SOLICITATION AMENDMENT 02

Title – Sujet Highway 4 Alder Removal - Pacific Rim National Park Reserve, BC		
Solicitation No. - N° de l'invitation : 5P420-18-0349/A	Amendment No. : 02	Date: December 27, 2018
GETS Reference No. N° de reference de SEAG : PW-18-00853292		
Solicitation Closes - L'invitation prend fin		
At - à : 02:00 PM On - le : January 3, 2019		Time Zone - Fuseau horaire : MST
F.O.B. - F.A.B. Plant - Usine : <input type="checkbox"/> Destination : <input checked="" type="checkbox"/> Other - Autre : <input type="checkbox"/>		
Address Inquiries to to - Adresser toutes questions à Adam Tan		
Telephone No. : (587) 436-5793	Fax No.: 1-866-246-6893	Email Address : adam.tan@canada.ca

Amendment No. (02): This amendment is raised to address bidder questions and to amend Annex “A” – Statement of Work for changes brought forward from the bidder questions:

ALL OTHER TERMS AND CONDITIONS REMAIN THE SAME.

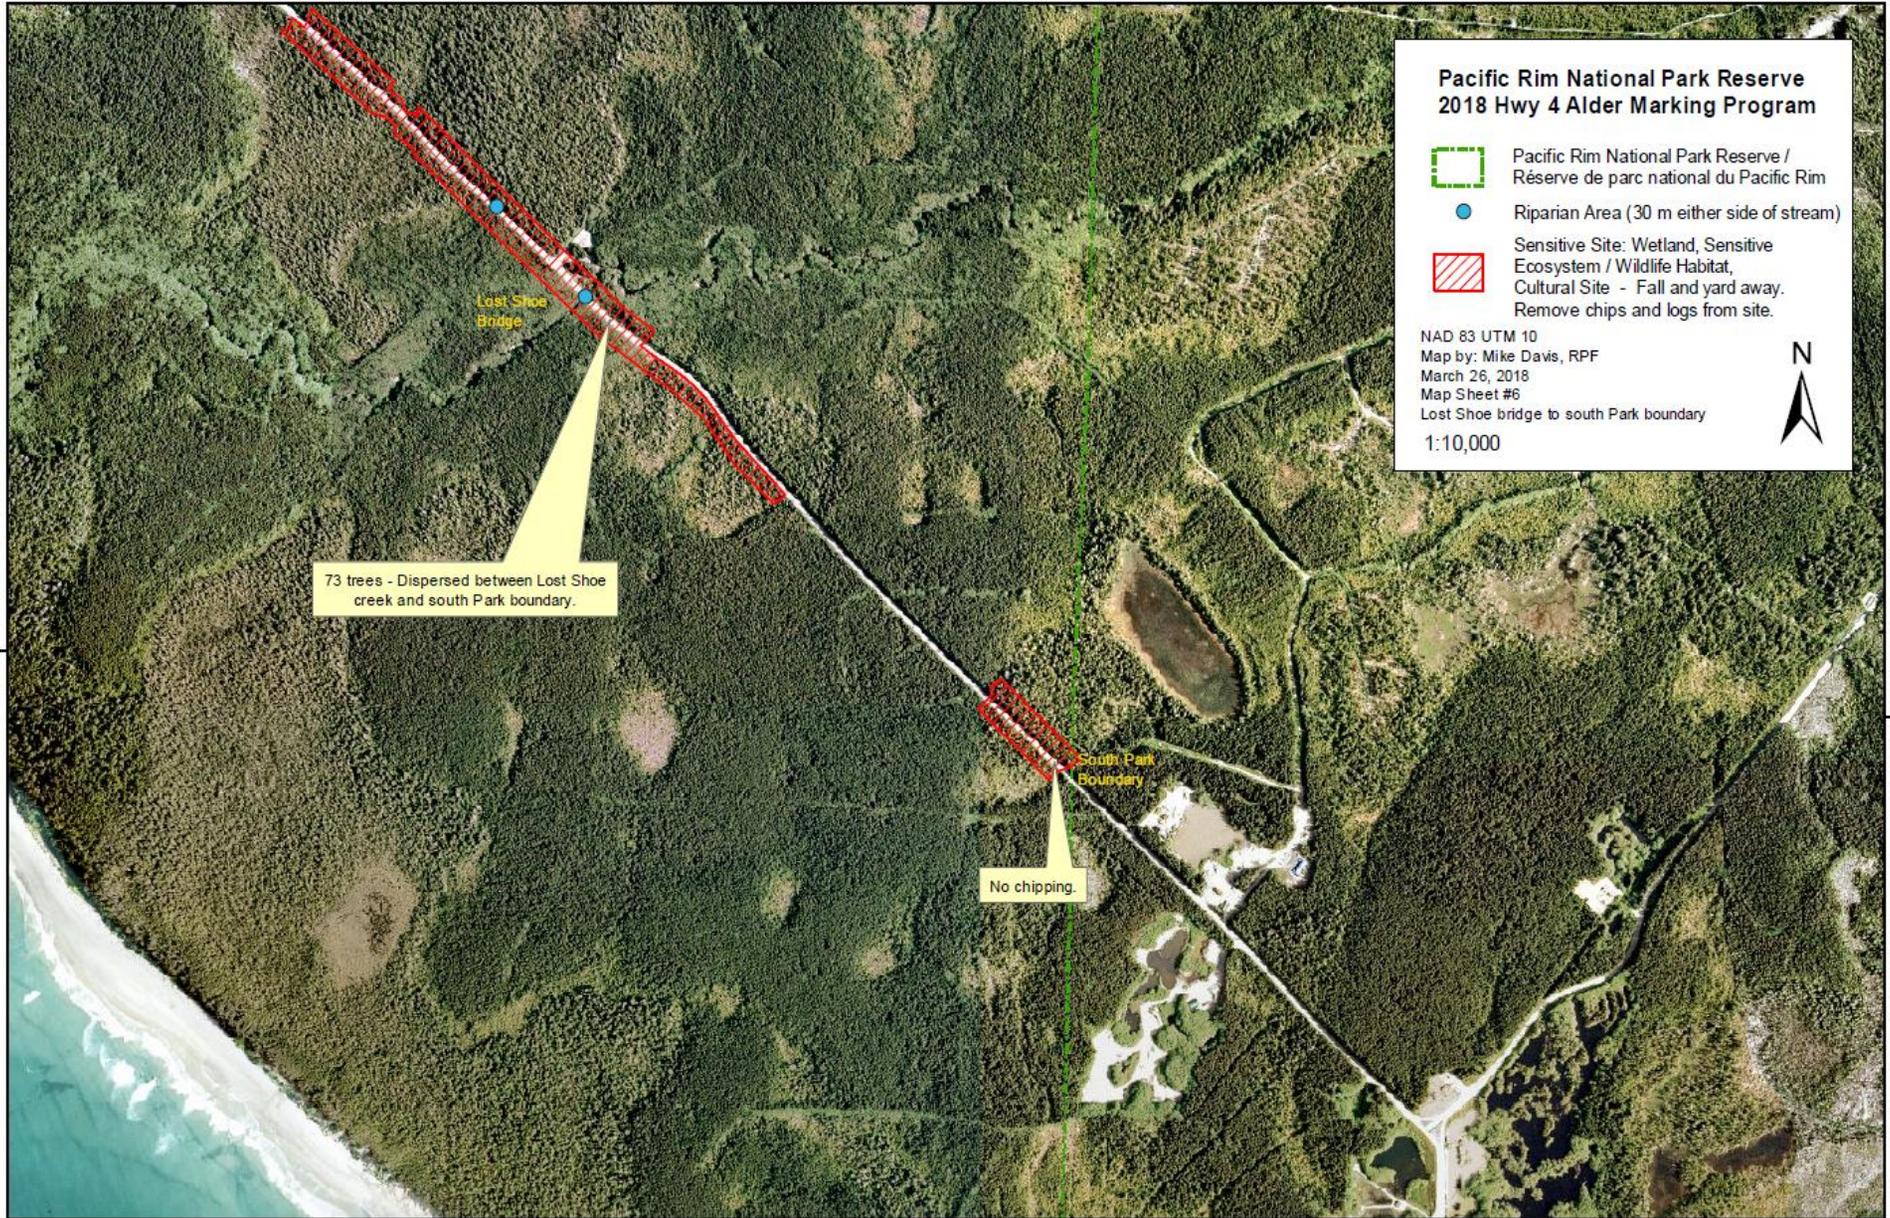
E) Amend Appendix A: Site Plan Map to include up to date maps

DELETE: Appendix A: Site Plan Map in its entirety and replace it with the following:

A2: No – all sites outlined in red on the maps are classified as sensitive areas. These make up the majority of the project area. Fall and yard away. Remove chips and logs from site.
